Revision to GRE/2016/29

(Proposal for Supplement 8 to the 01 series of amendments to Regulation
No. 123 (Adaptive front lighting systems (AFS)))

"Figure 1

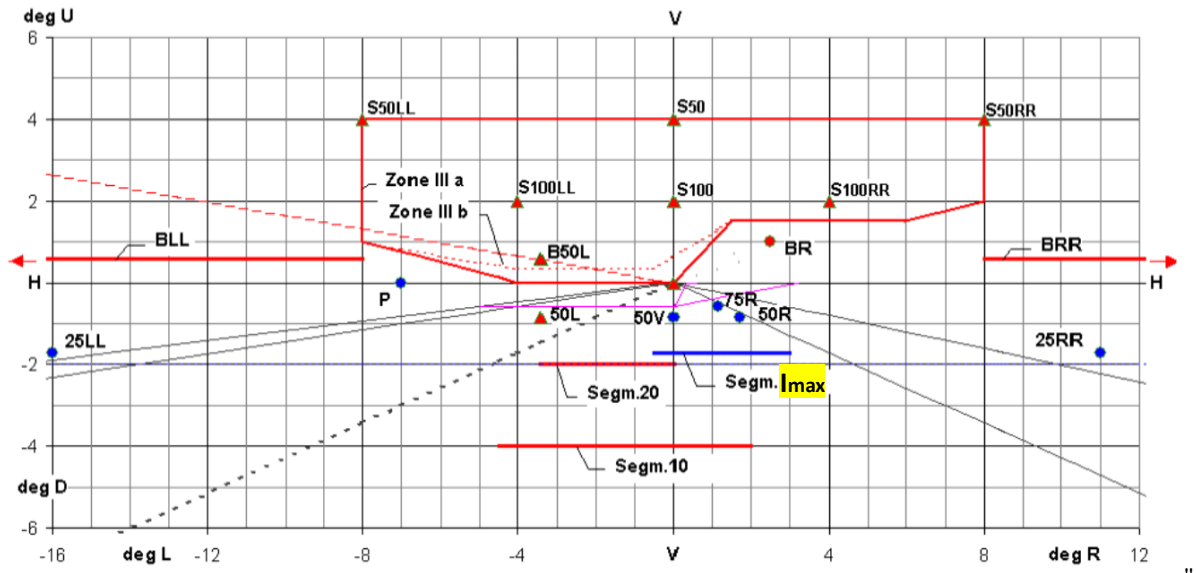
Annex 3, Figure 1, amend to show (change I_{max} is highlighted yellow):
